**Review of the Standard Modular High Temperature
Gas Cooled Reactor Probabilistic Risk Assessment**

Science Applications International Corporation

October 16, 1987

Exhibit 4-1. MHTGR PRA Initiator Definition Process.

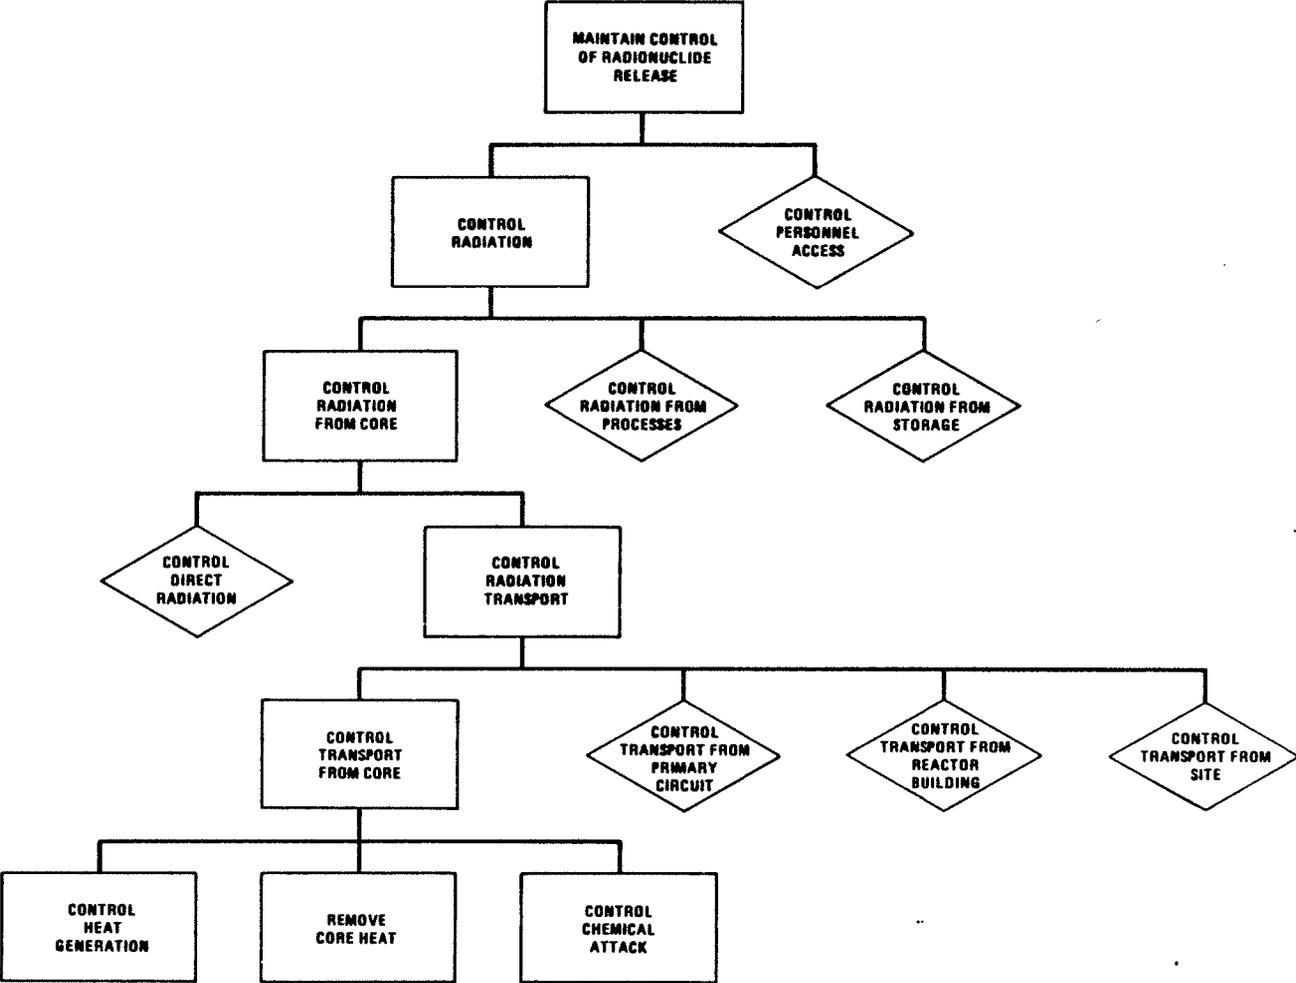
The PRA studied a limited set of initiator classes. Fires and floods were considered too plant-specific to assess but earthquakes were not. Losses of certain front line systems were addressed as initiators but loss of support systems were not. Eliminating fires and floods for the stated reason was justified but could have large risk impact, since several LWR PRAs have found these sequences significant. Earthquakes are plant- and site-specific and cannot be assessed in a generic fashion, as was done, with any credibility. Also, several LWR PRAs have found dominant risk sources in the service water system, dc equipment and batteries, instrument air, HVAC, and other support systems.

Because of the low sequence frequencies calculated in the PRA, it is also possible that other initiators, such as weather-related events (which might impact the RCCS), initiators which impact spent-fuel cooling, and initiators at conditions other than power operation may contribute relatively significant sequences.

Contemporary PRAs typically use initiator listings (see, for example, Tables 2-3 and 2-4 of Reference 4) as a basis for initiating event selection in lieu of defining a set of events through a top-down approach, which may miss historically observed initiators or events which are of specific concern for other reasons. Such listings have been developed based on initiators addressed in numerous PRAs. In addition, system-based initiators, including those associated with support systems, are also identified during system analysis in a contemporary PRA. These initiators can be important because of their impact on multiple front-line systems. Examples of such events include failure of service water or instrument air.

Use of initiator listings such as those included in Reference 4 in developing MGTGR-related initiators would increase the confidence in the completeness of the initiator set addressed. Assumed system dependencies identified in Table 4-3 of Reference 1 were used in developing the fault trees used in the PRA. This information could also aid definition of a set of system-based initiators, again adding to the confidence in the overall initiator set.

Exhibit 7-1. MHTGR Estimated Whole Body Dose-Frequency Curve at EAB.

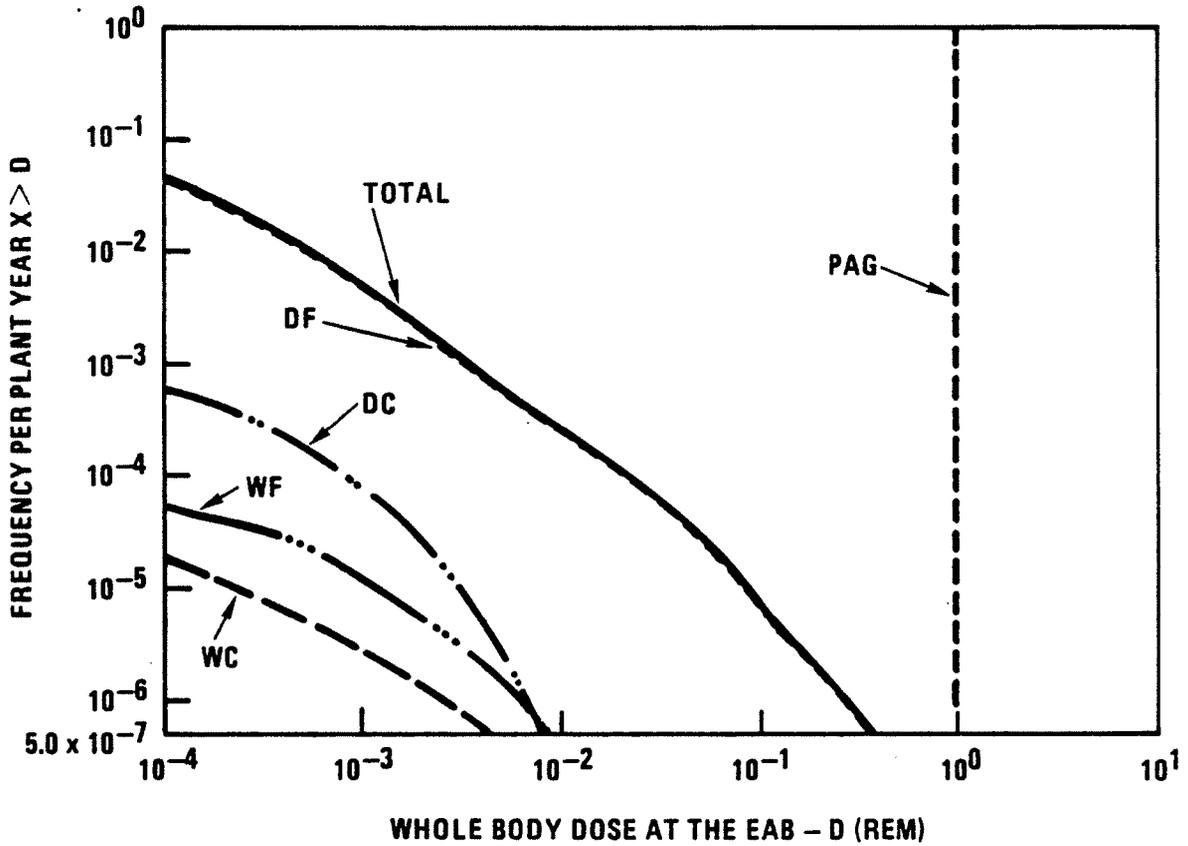
Frequencies and associated whole-body doses for all release category types are shown in Exhibit 7-1. The largest 30-day EAB doses in each of the four category types estimated in Reference 1 are also given in Table 7-1.

PWR and PWR 8 are "design basis accidents" and PWR 6 and PWR 7 are core melt accidents in which containment does not fail directly to the atmosphere. To compare with current LWRs on a per-MWe basis, estimated MHTGR consequences would need to be increased by nearly an order of magnitude.
